OIL - ENGINE - FANCASE - REPLACE IDG POWER CABLE SUPPORT BRACKETS - CATEGORY CODE 6 -
MOD.ENG-79-0045

V2500-ENG-79-0045

INSTALLATION OF IDG CABLE SUPPORT BRACKETS
Fig.1 (SHEET 1)

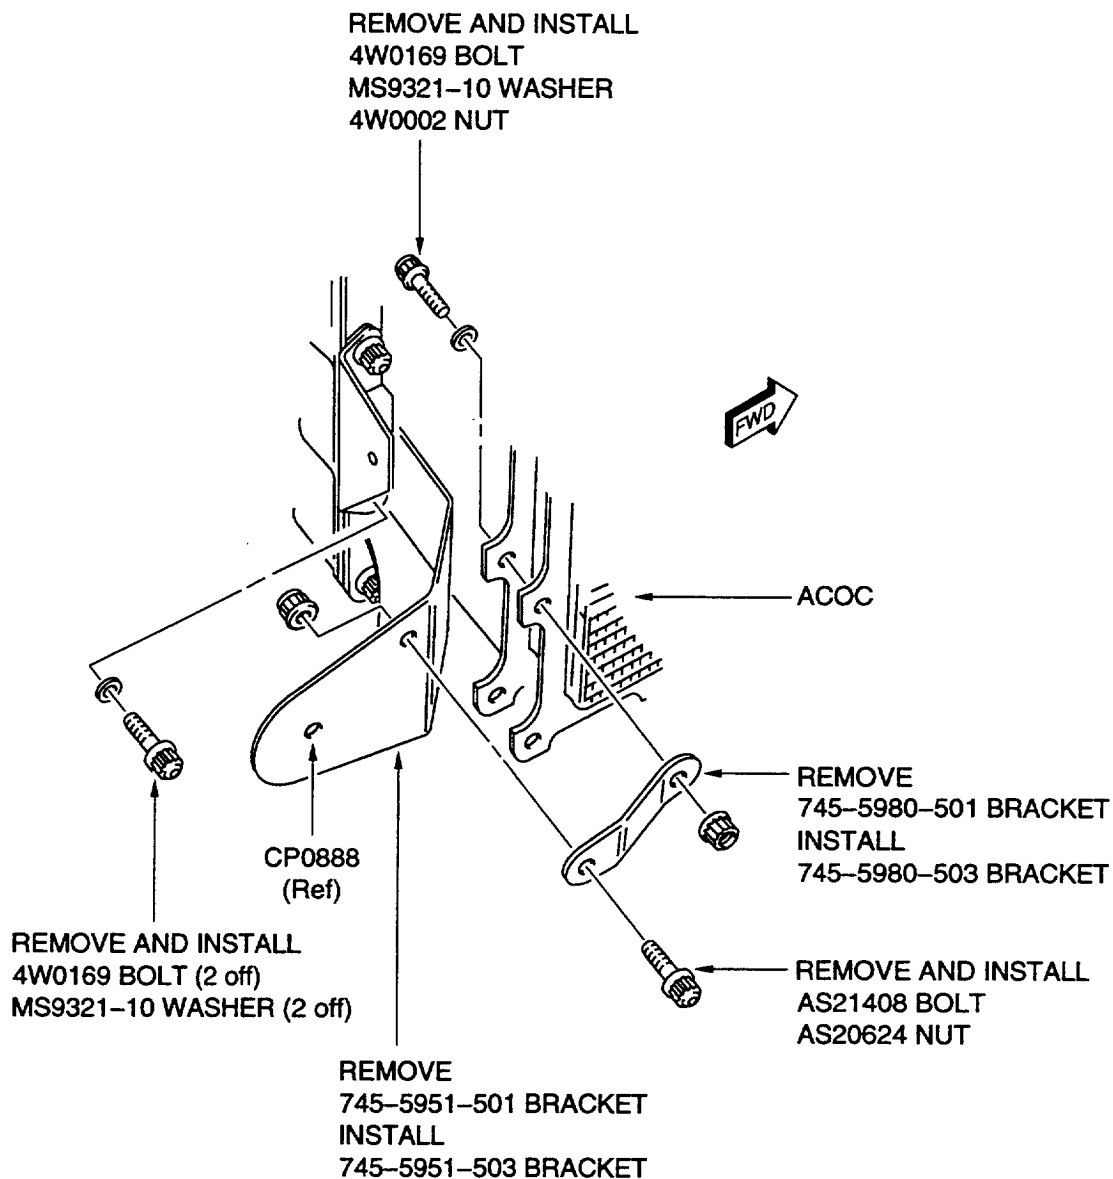
A new bracket and bracket support is introduced to replace the existing IDG power cable bracketry at clipping point CP0888

- (1) Install the new 745-5951-503 Bracket as shown with two 4W0169 Bolts and two MS9321-10 Washers. (Refer to Figures 1 and 2). Torque the bolts to 85 to 105 lb in (10 to 12 Nm).
- (2) Install the new 745-5980-503 Bracket as shown with a 4W0169 Bolt, MS9321-10 Washer, 4W0002 Nut, AS21408 Bolt and an AS20624 Nut. Torque the bolts to 36 to 45 lb in (4 to 5 Nm).
- (3) Assemble clipping point CP0888 as shown with an AS20624 Nut, AS21410 Bolt, SP154D Washer and TA025074-18 clamp. Torque the nut to 20 to 25 lb in (2 to 3 Nm).
